APPEAL SUMMARY

| Appeal ID: 23500 | Project Address: 2133 N Argyle St |
| Project Type: commercial | Stories: 4 Occupancy: R-2 Construction Type: V-A |

Appeal item 1

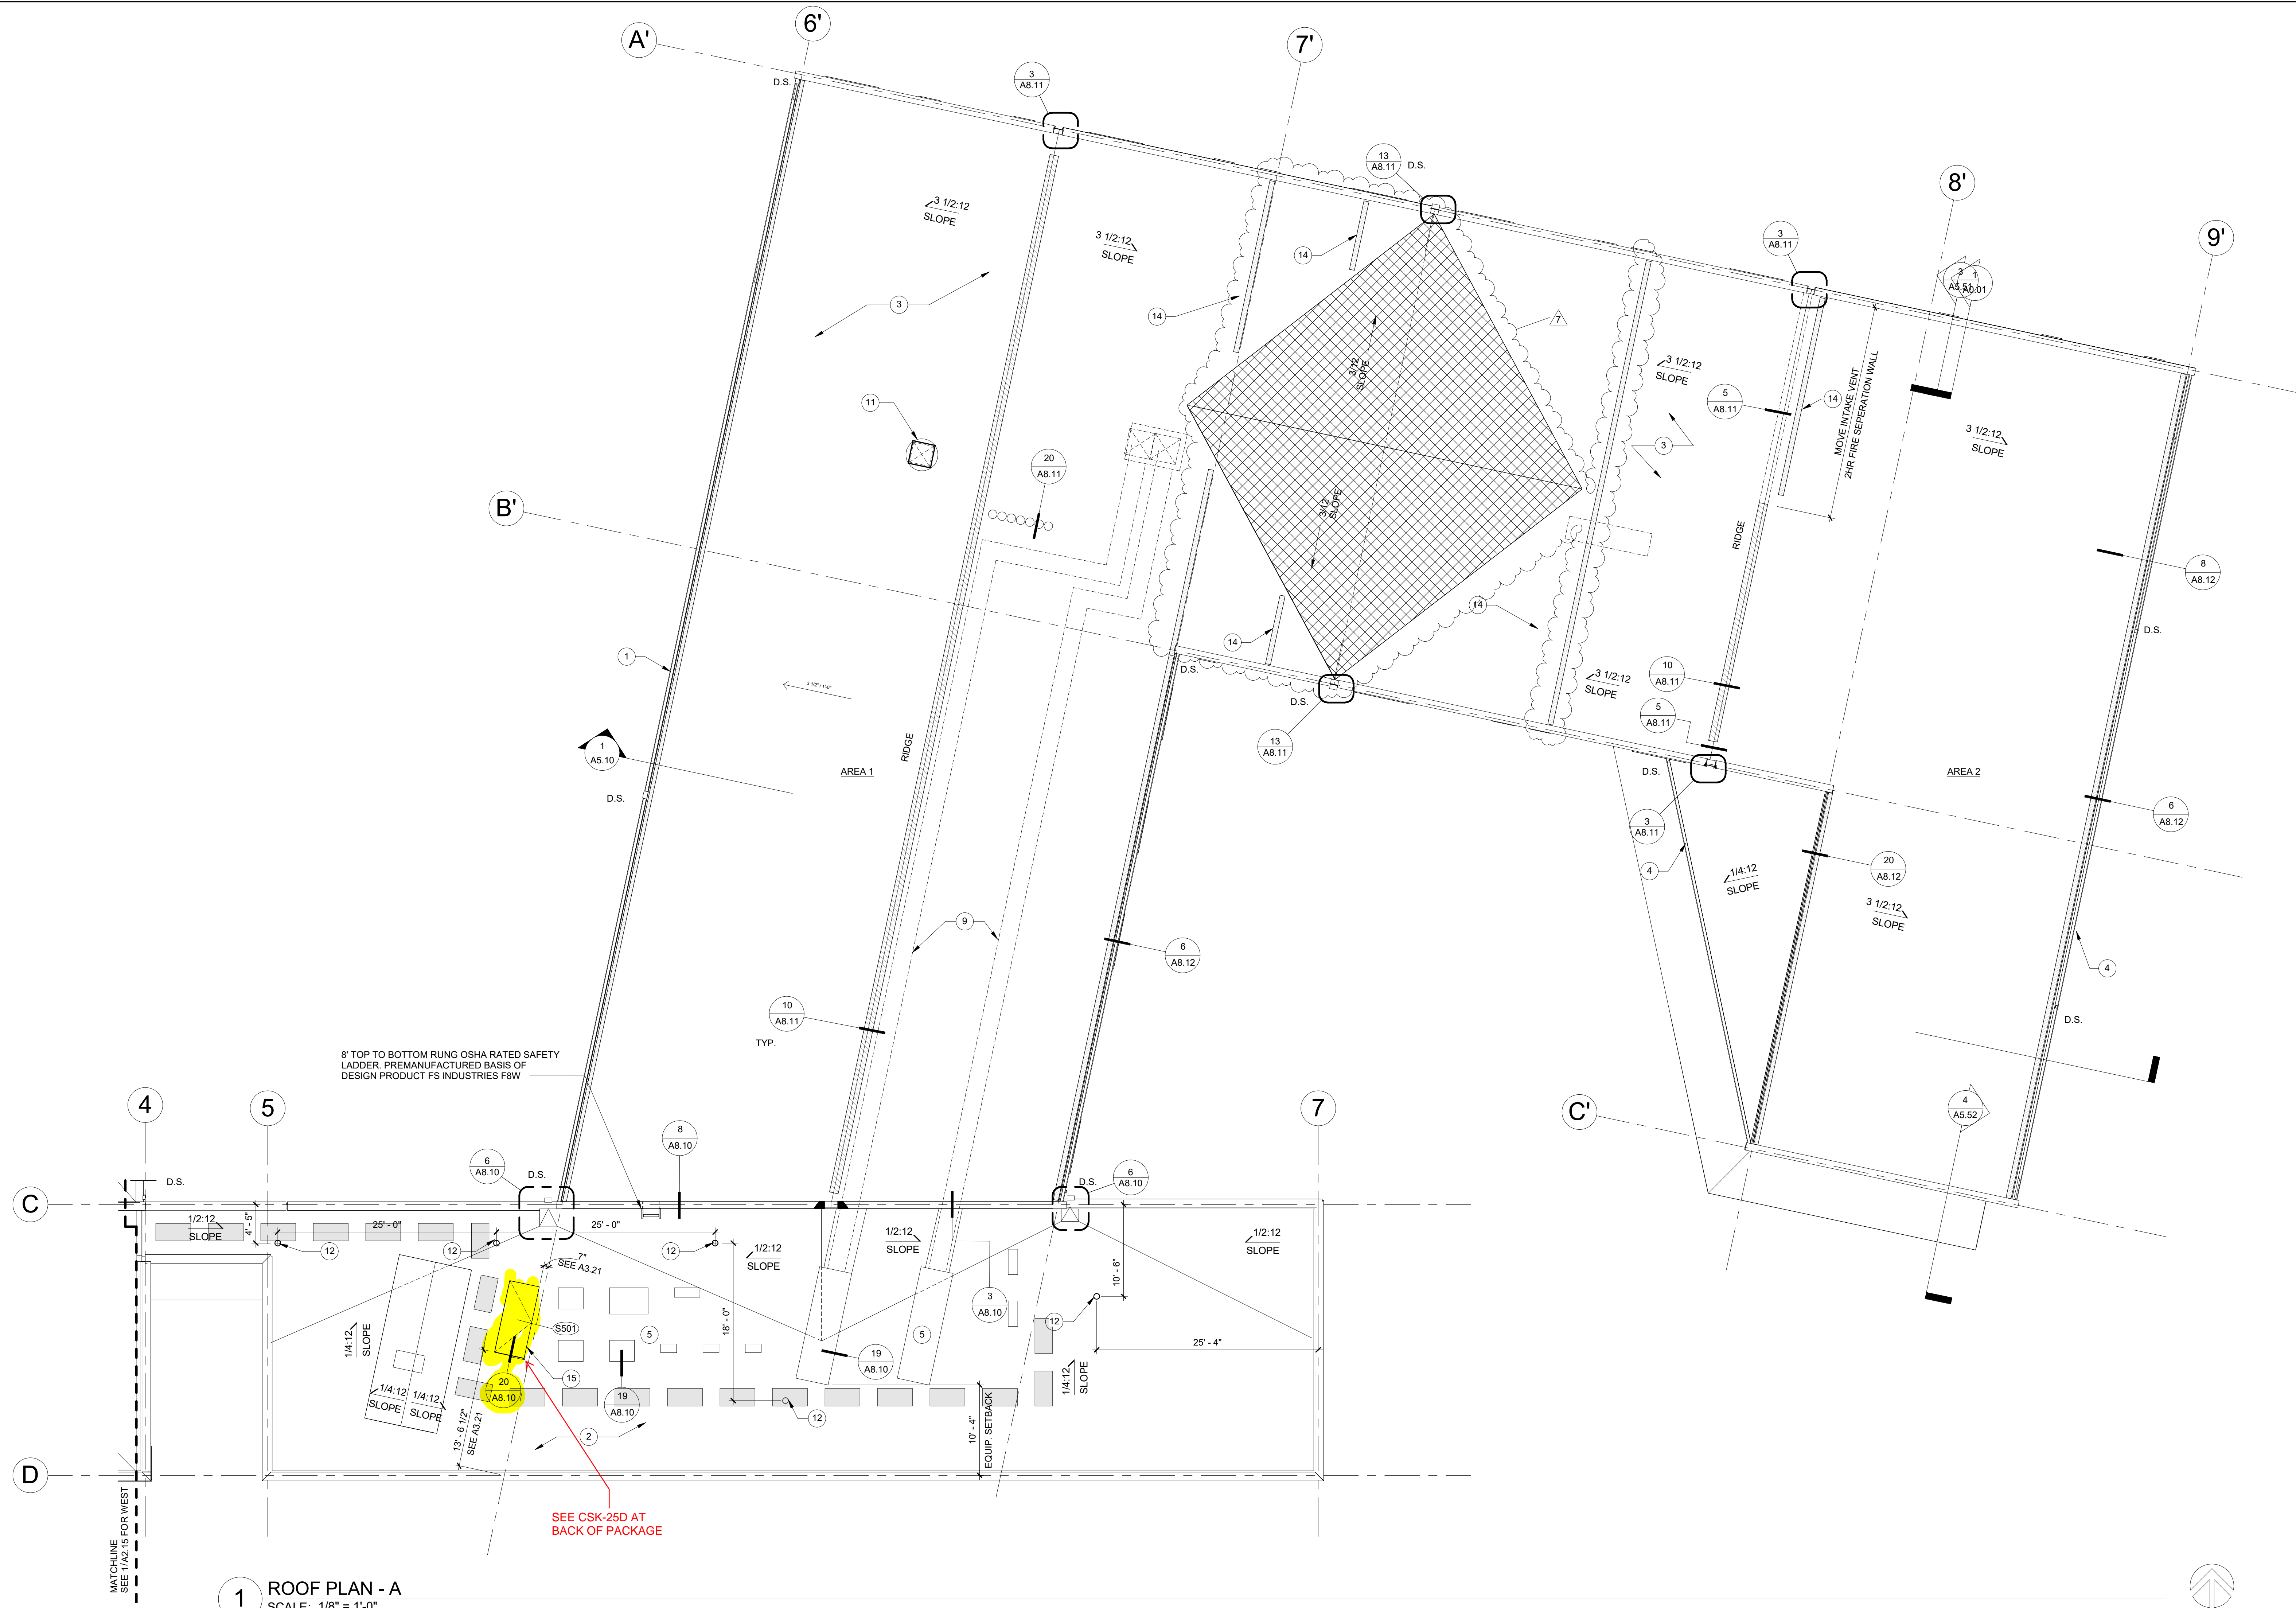
Proposed Design The project has two roof hatches with overall dimensions of 3'-0" x 8'-0". We propose to construct the ship's ladders from the stairways to the rooftop with overall widths of 33" leaving 30" clear between the handrails while still maintaining 1 1/2" clear between the outside of one handrail to the wall. At the plane of the framed ceiling opening, we will continue one handrail to the roof. Our proposal will allow one entirely clear graspable surface to run continuously, but the framed opening and sheetrock can remain.

Reason for alternative Section 1009.16 Stairway to roof requires a 30 inch wide between handrails. To have full bearing for the roof hatch attachment angle on the roof trusses below, and then drywall and framing on each side of the access hatch, the overall width of the area becomes roughly 34.75". To provide a consistent and maximum width for handrails and treads, while maintaining handrail clearances from walls (1 1/2"), and fit within, an overall width of 33" is achievable for the stair with only a single handrail to the roof from the bottom of the ceiling plane. This yields a clear handrail to

handrail dimension of 30" to the ceiling and one handrail extended through the hole with 1'1/2" clearance.

The proposed design works with the structural bearing of the ship's ladder while allowing safe access to the roof. The 1-1/2" diameter handrail with 1-1/2" clearance will be set on the access handle/latch side of the hatch so the user will not have to reach across the access hatch for leverage. (See the last page of attached .pdf package for diagram)

Ships ladder to unoccupied roof with omission of one handrail at roof access hatch: Granted provided two handrails are installed with 1.5 inch clearance on each side and reduced clear width between handrails.
